## Revised Comments on Proposed Amendments of the Bay-Delta Water Quality Control Plan's Compliance and Baseline Monitoring Program

November 30, 2004

Figure 4: Proposed Revision of Figure 2 of the 1995 Bay-Delta Water Quality Control Plan

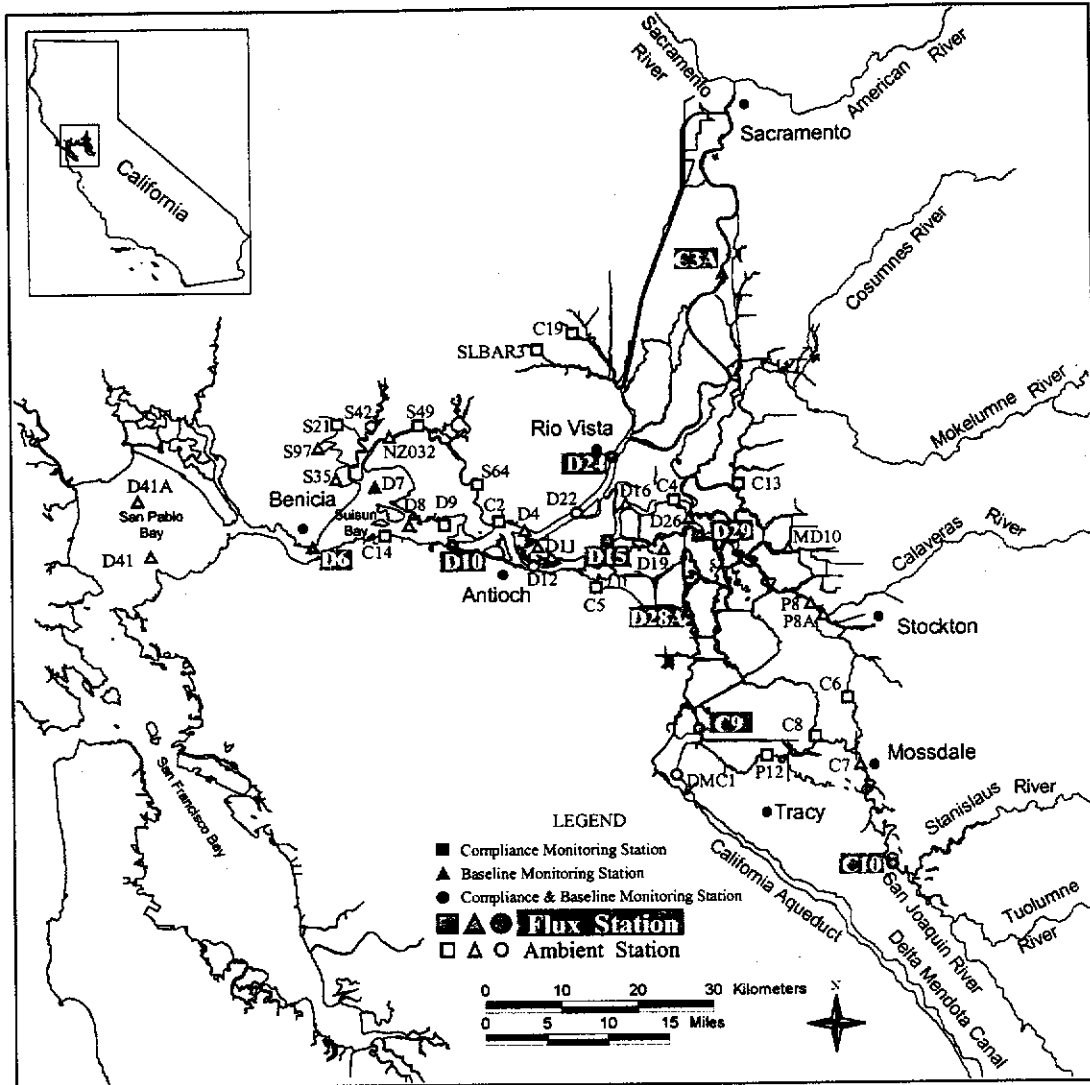
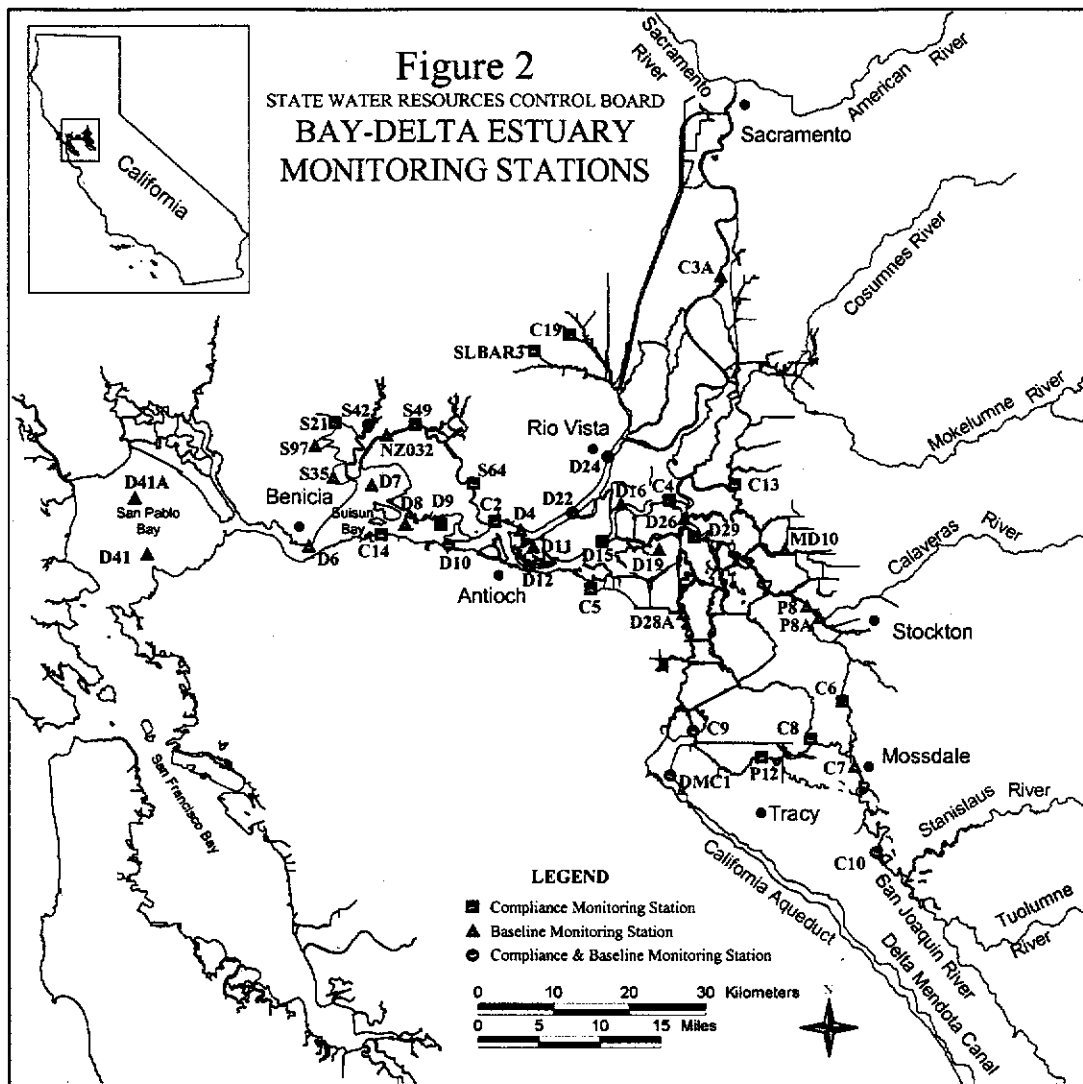
The amendment of Figure 2 of the Plan would reflect the previously proposed changes to the monitoring plan. Figure 4 of this document shows the proposed revision of the Plan's Figure 2.

Figure 3: Comparison of Greens Landing (C3) and Hood (C3A) Monitoring Stations (July 2003-June 2004, 16 constituents, Deming regression and Bias plots: no significant differences between stations (see Triboli et al, IEP newsletter 2003(4):13-24 for statistical analysis techniques))

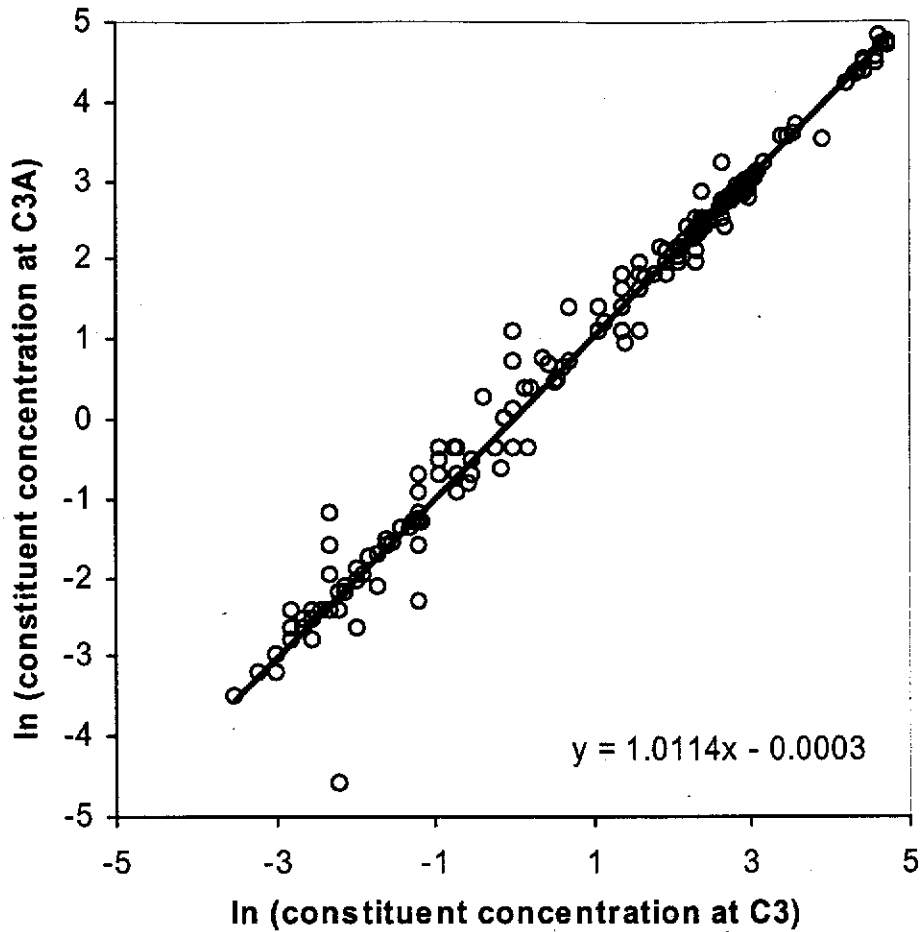
- 17 monitoring elements would remain unchanged
- 4 monitoring elements would remain operationally unchanged but would be identified with new station numbers
- 8 historically monitored elements would be reestablished
- 1 historically monitored elements would be removed
- 8 baseline monitoring elements would be added
- 2 baseline monitoring elements would be moved to consolidate two neighboring stations (Hood & Greens Landing) for greater sampling efficiency. Comparisons of monitoring data from these two stations show no differences (Figure 3 of this document).
